Request	-	Planned Unit Development for Multiple Commercial Buildings on a lot
Location	-	3027 Alexis Road
Applicant/Owner	-	Board of Trustees of the Toledo Lucas County Public Library 325 Michigan Street Toledo, OH 43604
Architect	-	Bostwick Design Partnership 2729 Prospect Avenue Cleveland, OH 44115
Engineer	-	DGL Consulting Engineers 3455 Briarfield Blvd, Suite E Maumee, OH 43537

The staff recommends that the Toledo City Plan Commission recommend **approval** of PUD24-0001, a request for Planned Unit Development for multiple commercial buildings on a lot at 3027 Alexis Road to Toledo City Council for the following **two reasons**:

PLANNED UNIT DEVELOPMENT  
TOLEDO CITY PLAN COMMISSION  
REF: PUD24-0001  
DATE: February 13, 2025  
TIME: 2:00 P.M.

**PUD24-0001**

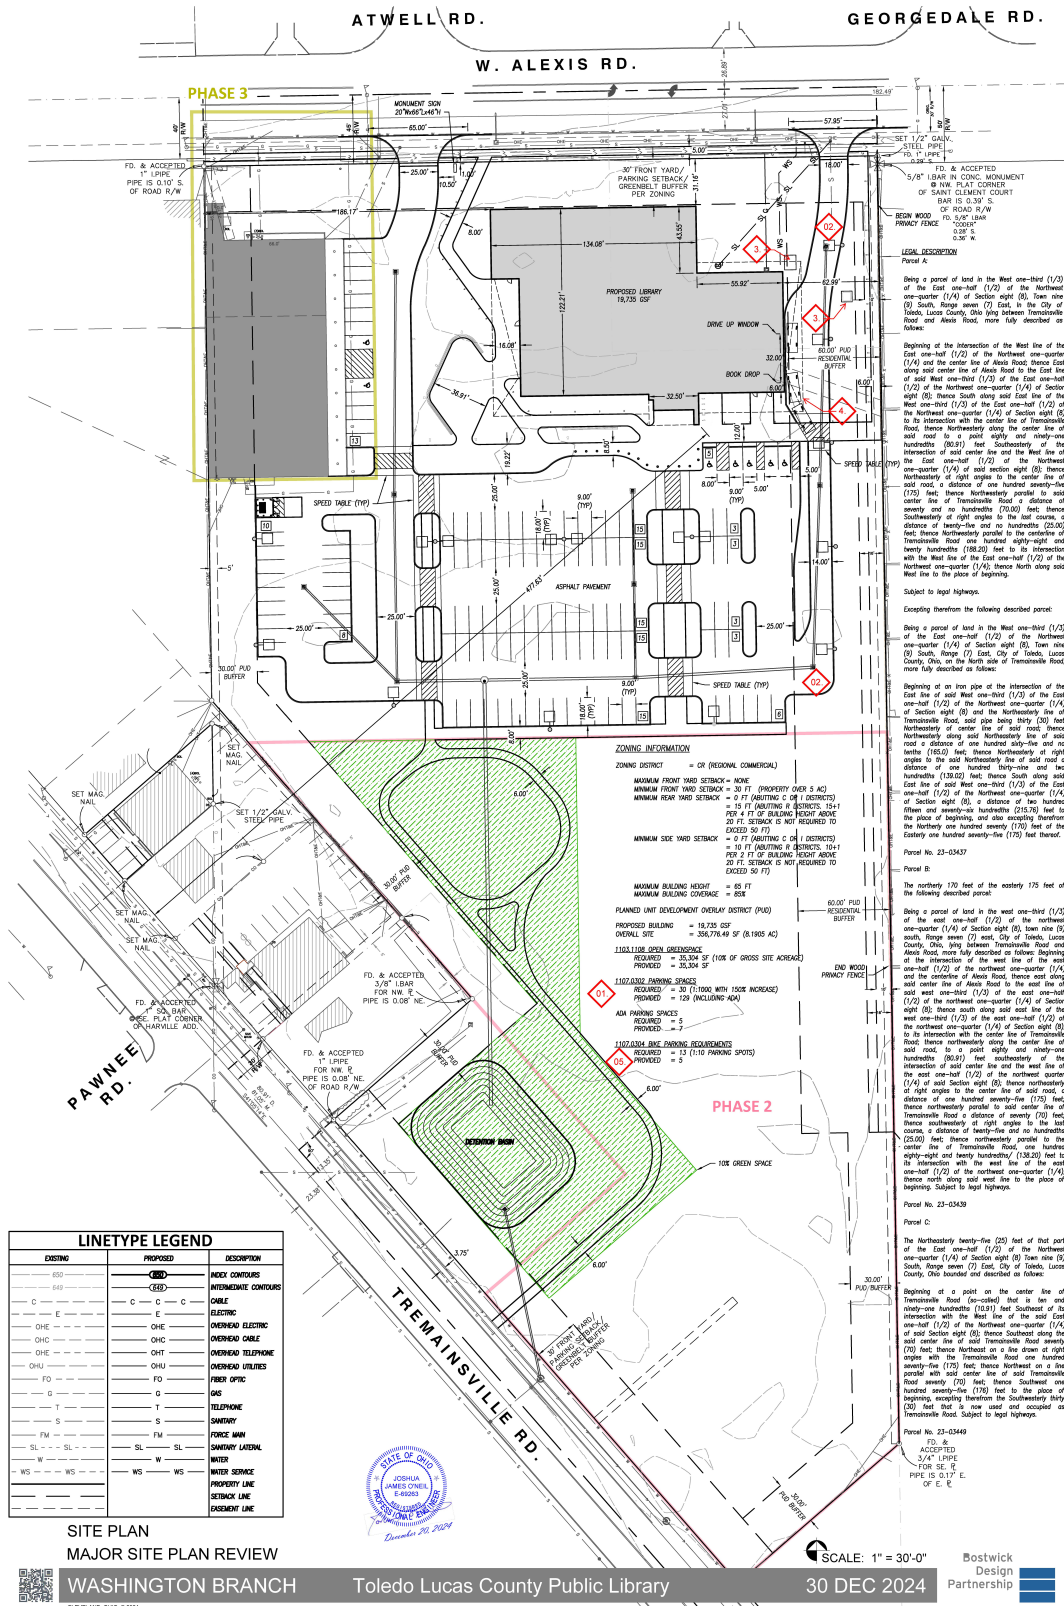
28. "Do Not Enter" signage is required at the 18' wide driveway to prevent wrong way traffic flow.

29. Sidewalk must continue through driveways along Alexis Road.

33. Per TMC§1107.0304, the Off-Street Parking Schedule requires one bicycle parking slot per 10 parking spots, requiring a total of thirteen (13). Five (5) bicycle slots are depicted on the site plan. **Not acceptable as depicted. Eight (8) additional bicycle slots shall be provided.**

35. Per TMC§1103.1008(B) commercial PUD developments shall maintain a minimum open space depth of 30 feet on all perimeter property lines and a minimum open space depth of 60 feet when abutting a Residential District. This open space area must be void of buildings, structures, parking areas and other above ground improvements. The submitted site plans and elevations show that a portion of the main building roof, the drive-up material return and service window roof, the drive through lane, a sidewalk, a transformer and a condenser will be located within the required sixty foot (60') open space along the east side of the site. **Not acceptable as depicted. The applicant shall obtain a waiver for the required open space depth where it does not comply.**

38. Traditional detention/retention ponds are prohibited in the front yard per TMC§1108.0206(D). Stormwater treatment facilities shall also meet the approval of the City of Toledo's Division of Engineering Services. **Not acceptable as depicted. The proposed detention basin will need to be relocated so that it is not in the front yard and approved by the Division of Engineering Services.**

- f. Per TMC§1103.1007(H), all telephone, electrical, cable, and other utility appurtenances shall be buried and dumpsters shall be sufficiently screened. **Not acceptable as depicted. Dumpster enclosure details shall be provided.**

SITE TREE PLANTING PLAN  
MAJOR SITE PLAN REVIEW

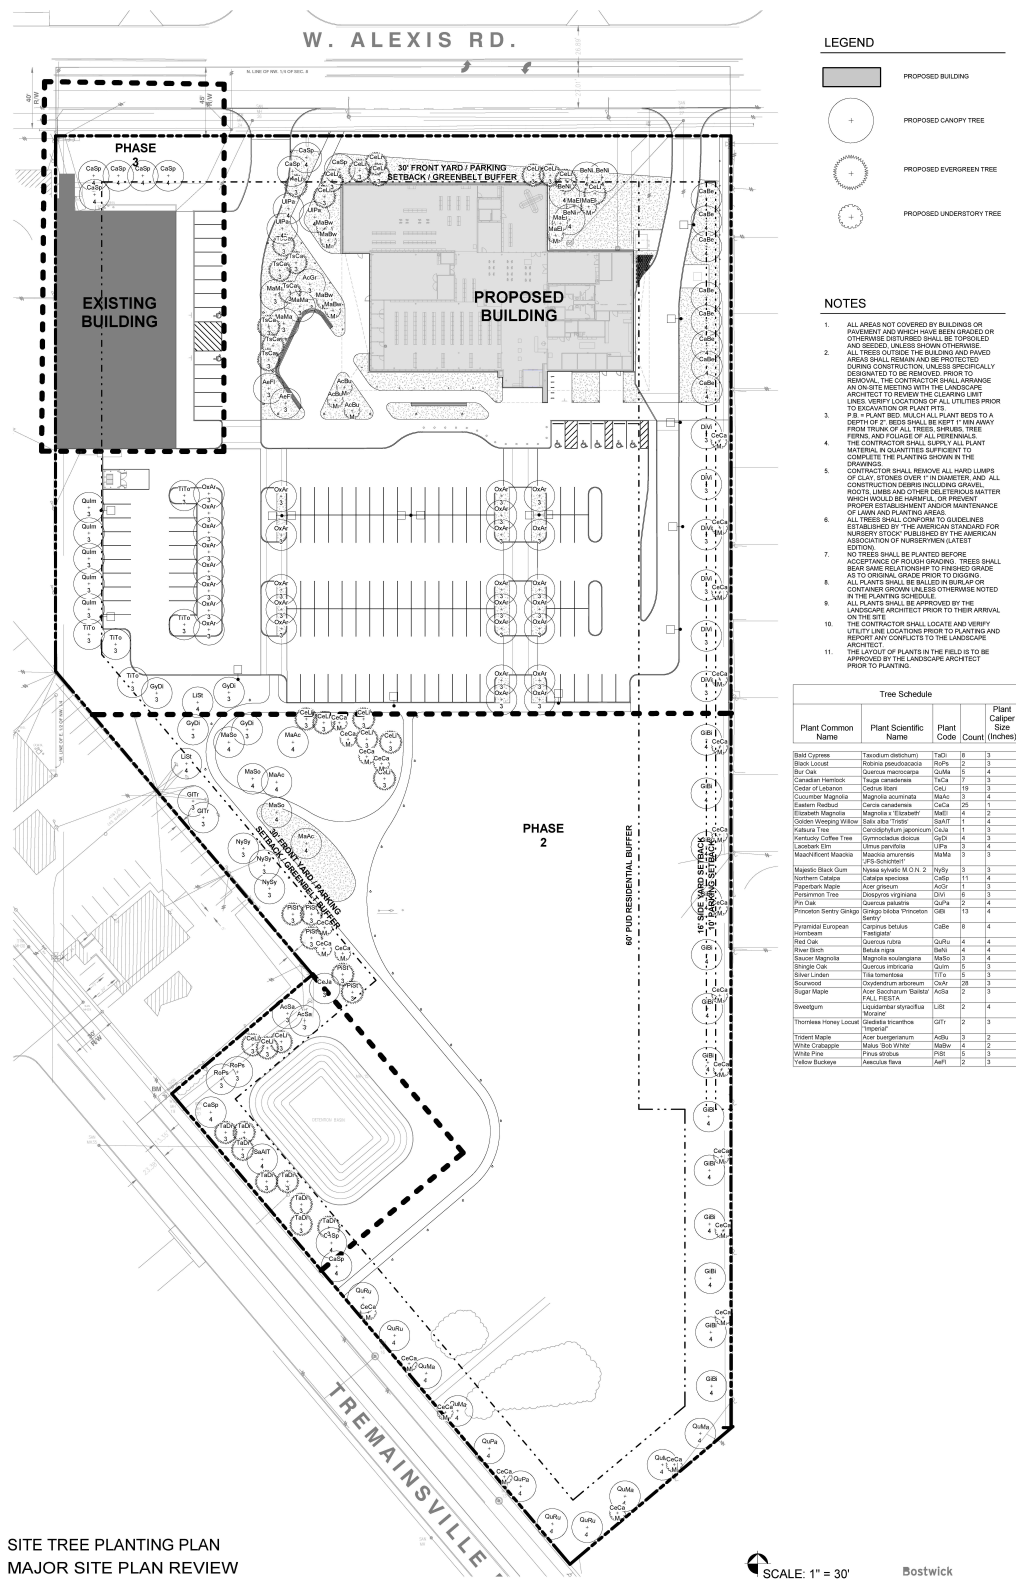
- a. Per TMC§1108.0202, a minimum 30-foot-wide frontage greenbelt along public right-of-ways is required that contains at least one (1) tree for every thirty feet (30') of frontage. This applies to the north and south sides of the property. **Acceptable as depicted. While acceptable as depicted, any evergreen trees installed in the frontage greenbelt must be a minimum of eighteen feet (18') from the curb or pavement edge per TMC§1107.2000.**

- b. Per TMC§1108.0203, a Type A buffer is required along a portion of the east property line and a Type B Buffer is required along the other portion of the east property line. These two (2) buffers require a total thirty-four (34) canopy trees and 127 shrubs along the eastern property line. The landscape plan depicts twenty-seven (27) canopy trees and twelve (12) understory trees for an equivalent of thirty-five (35) canopy trees. The site plan also depicts 136 shrubs. **Acceptable as depicted.**

- d. Perimeter landscaping must be installed along any parking lot area adjacent to a street, place or driveway, or which is visible from an adjacent property. The tree planting plan and shrub planting plan depict trees and shrubs along the west side of the parking lot, and trees and a six-foot (6') high cedar privacy fence along the east side of the parking lot. **Not acceptable as submitted. The proposed continuous shrub hedge depicted on the shrub planting plan along the west side of the parking lot shall be extended to the south to include the drive aisle. The shrub hedge shall consist of evergreen shrubs. The privacy fence is acceptable in lieu of the required continuous shrub hedge along the east side of the parking lot per the Plan Director.**

SITE SHRUB PLANTING PLAN  
MAJOR SITE PLAN REVIEW

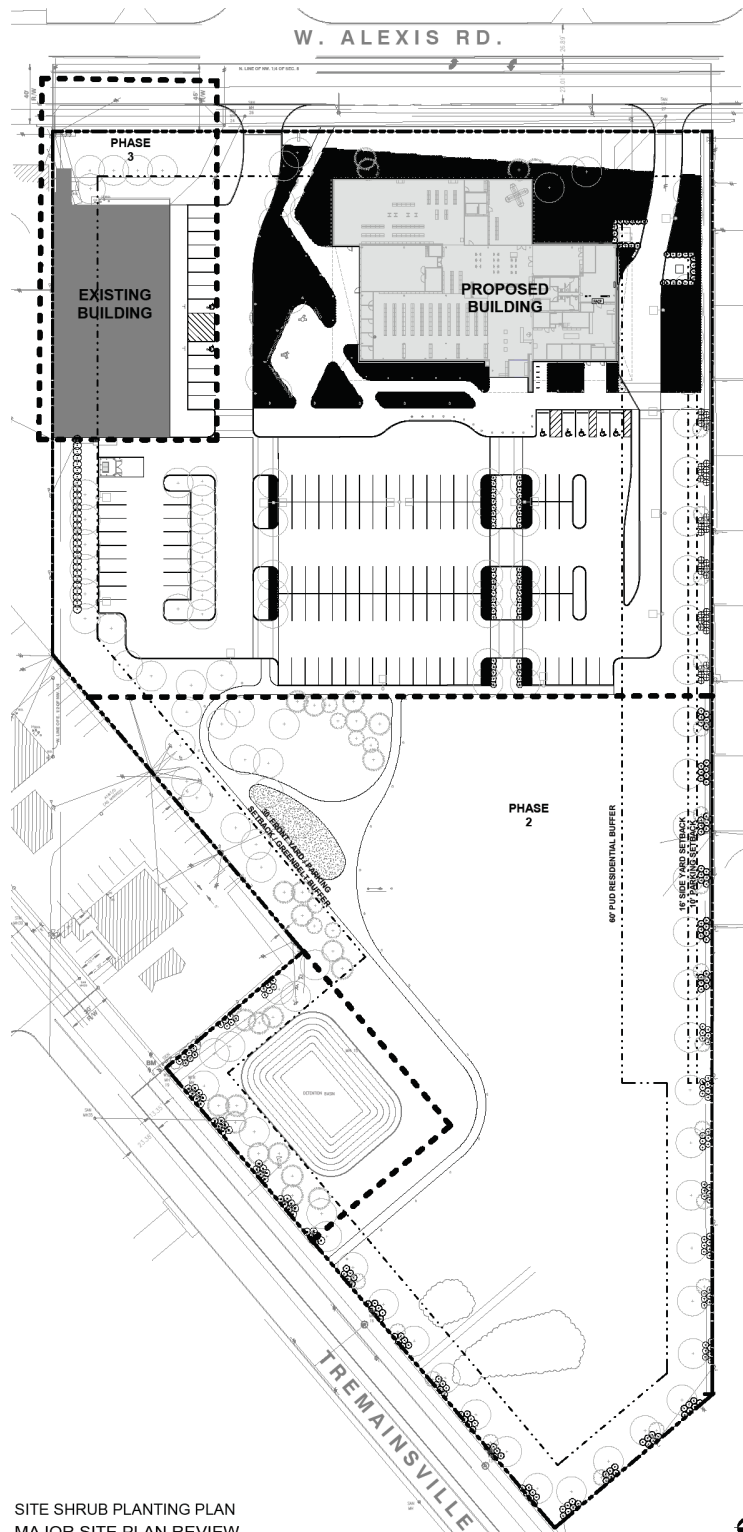
- c. Per TMC§1108.0204, two (2) canopy trees and six (6) shrubs are required to be installed in interior landscape areas in a parking lot for each ten (10) parking spaces. A total of twenty-six (26) trees and seventy-eight (78) shrubs are required in the interior of the parking lot based on the proposed 129 parking spaces. The submitted tree planting plan and shrub planting plan depict thirty (30) trees and forty-six (46) shrubs. **Not acceptable as depicted. An additional thirty two (32) shrubs are required.**

- e. Per TMC§1108.0205(B), one 2-inch caliper tree for every 1,000 square feet of building coverage, foundation plantings along all portions of the building that are visible from the public rights-of-way, and landscaping at all major building entrances are required. **Not acceptable as depicted. A mix of trees, shrubs and groundcover shall be provided as foundation plantings along the entirety of the north, west and east sides of the building as well as at the main entrance.**

- g. Per TMC§1103.1209(A.3), grade level mechanical equipment shall be screened from adjoining residential parcels and from the right of way(s).
- h. Per TMC§1108.0204(B.6), landscaped areas may not contain bare soil, aggregated stone, or decorative rock. Any ground area must be covered with hardwood mulch, grass, or other vegetative ground coverage. The proposed rock mulch is not permitted.

- i. Topsoil must be back filled to provide positive drainage of the landscape area.
- j. The location, number, height, diameter, and species of any materials to be planted and maintained, as well as the location and number of any existing trees to be retained. **Not acceptable as depicted. A landscape plan shall be submitted that includes all proposed plant materials that are appropriately labeled.**

EXTERIOR ELEVATIONS  
MAJOR SITE PLAN REVIEW

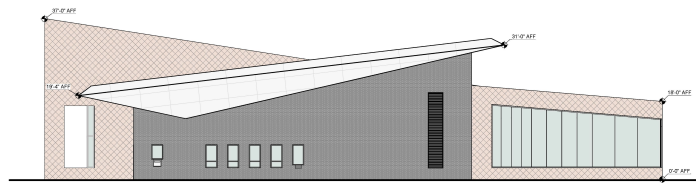
- n. The location, lighting, and size of any signs.
40. Landscaping shall be installed and maintained indefinitely.
41. Building elevations must meet TMC§1109 – Design Standards. The submitted elevations show a mix of proposed building materials including brick, stainless steel wall tiles, ultra-high performance concrete panels, and aluminum composite panels. Final building materials and colors have not been decided. **Not acceptable as submitted. Final elevations that include building materials and colors will need to be submitted that meet the standards of TMC§1109.**
